Rethinking the 800GBASE- ER1 model

Tom Huber (Nokia), Gary Nicholl (Cisco), Jeff Slavick (Broadcom),
Eugene Opsasnick (Broadcom), Andras deKoos (Microchip), Mike
Sluyski (Cisco), Dave Ofelt (Juniper)

Current 800GBASE-ER1 model is not self-consistent across possible PHY configurations

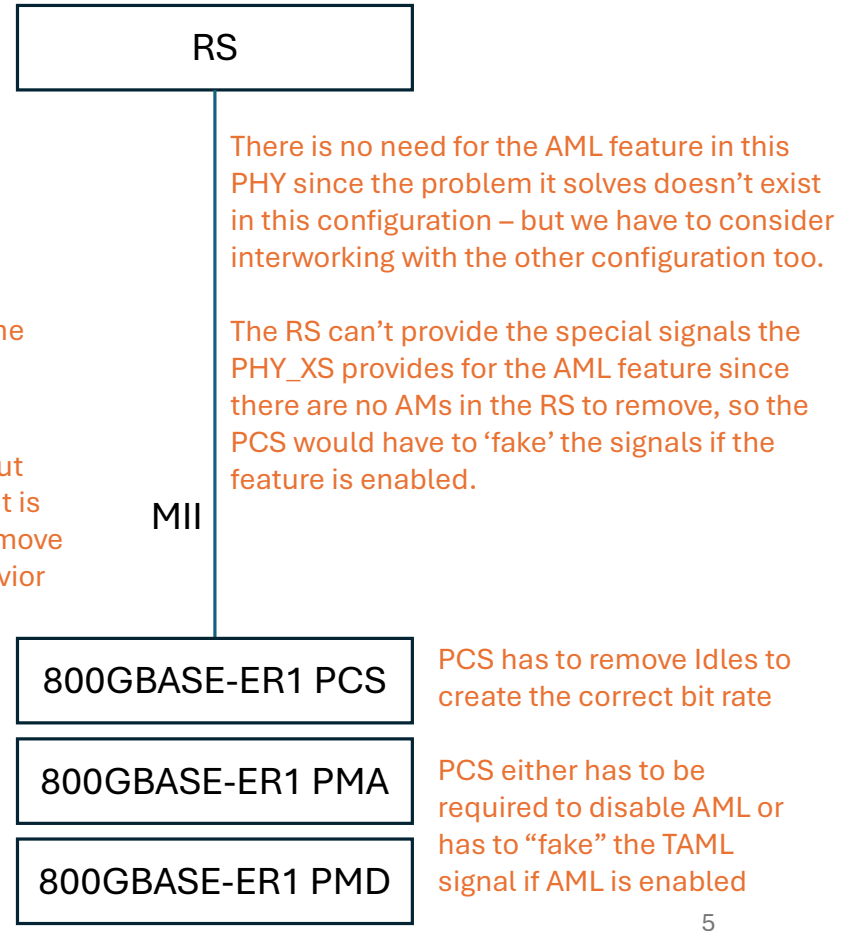
MII needs to include TAML and RAML signals if AML is used

MII rate will be different if Idles are not re-inserted

Need to share information between XS and PCS across the MII to make AML feature work, which requires XS to have ER1-specific behavior.

PHY_XS inserts Idles to compensate for removed AMs, but doing that significantly complicates the AML feature, so it is better to not insert Idles. But we specified the PCS to remove Idles, so we have to insert them... or make the PCS behavior dependent on whether it connects to an RS or PHY_XS

There is no need for the AML feature in this PHY since the problem it solves doesn't exist in this configuration – but we have to consider interworking with the other configuration too.

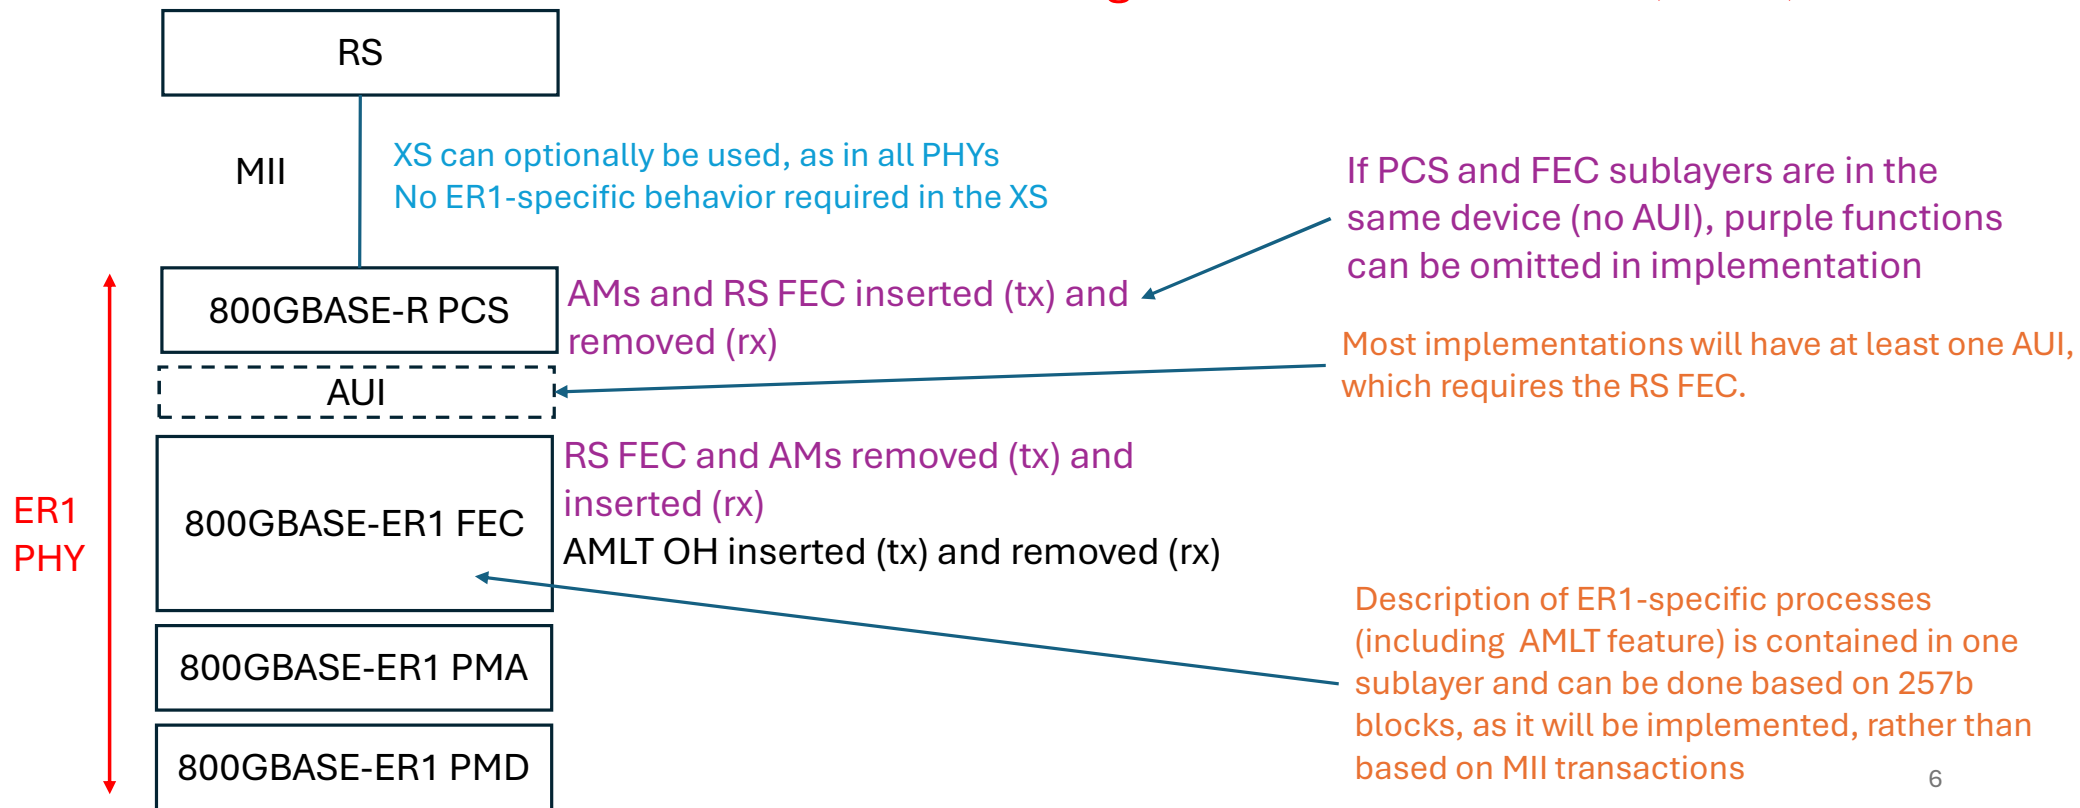
The RS can't provide the special signals the PHY_XS provides for the AML feature since there are no AMs in the RS to remove, so the PCS would have to 'fake' the signals if the feature is enabled.

PCS has to remove Idles to create the correct bit rate

PCS either has to be required to disable AML or has to "fake" the TAML signal if AML is enabled

PHY_XS functions used in ER1 FEC

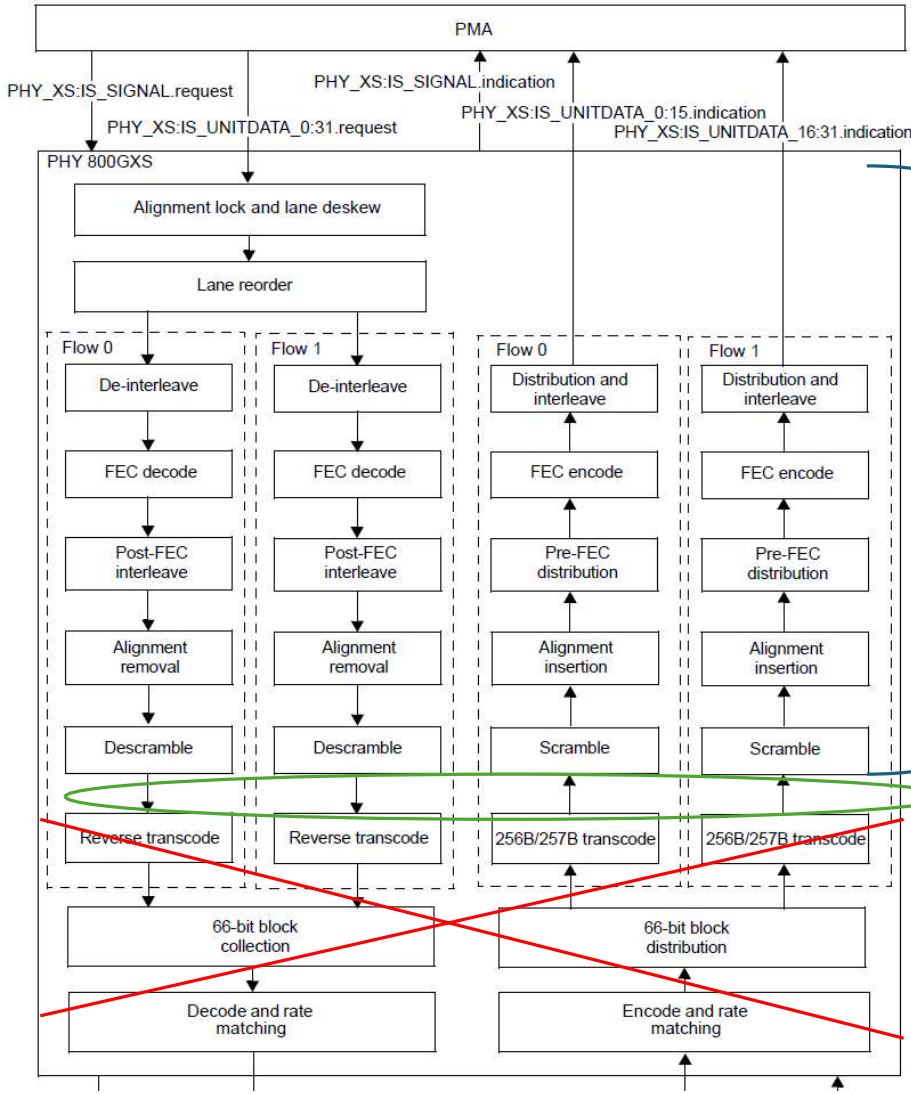
These processes are incorporated into the ER1 FEC sublayer but can all be specified by reference

Add a “flow merge”/”flow distribute” functions here to merge the two flows to a single stream of 257b blocks in the Tx path and distribute the single path to two flows in the Rx path

ER1 PCS functions used in ER1 FEC

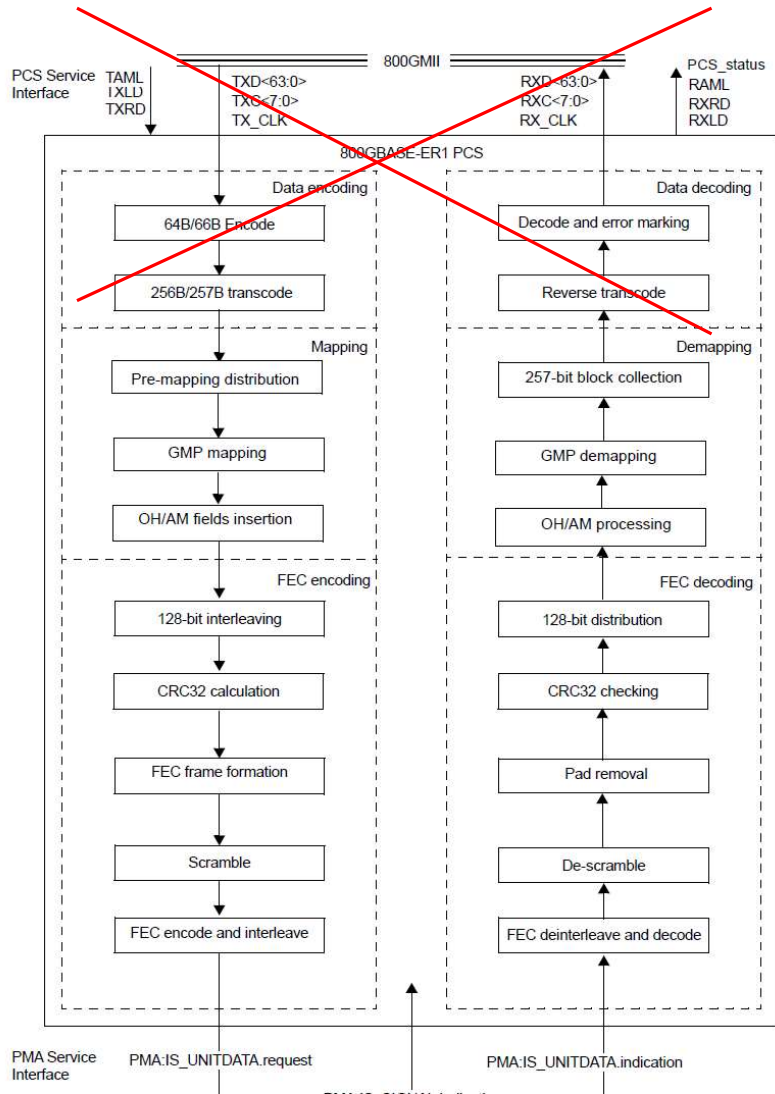
Replace this Data encoding/decoding block with a “Inverse RS FEC” block that uses functions from the PHY_XS (see previous slide) plus a “flow merge” function to combine the two flows into a single 257b block stream

No changes needed as a result of changing the architecture to a FEC sublayer, other than in description of AML field in the OH/AM fields insertion function

New ER1 FEC sublayer

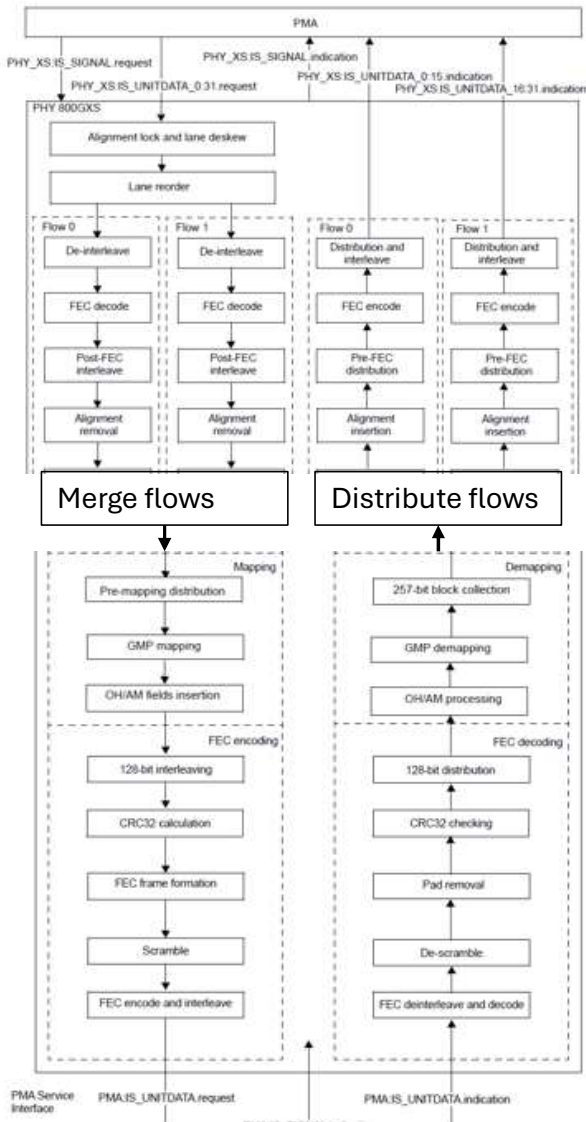
Functions defined by reference to the PHY_XS

New functions to 802.3dj, but defined already in OIF and ITU-T

Functions currently in 800GBASE-ER1 PCS
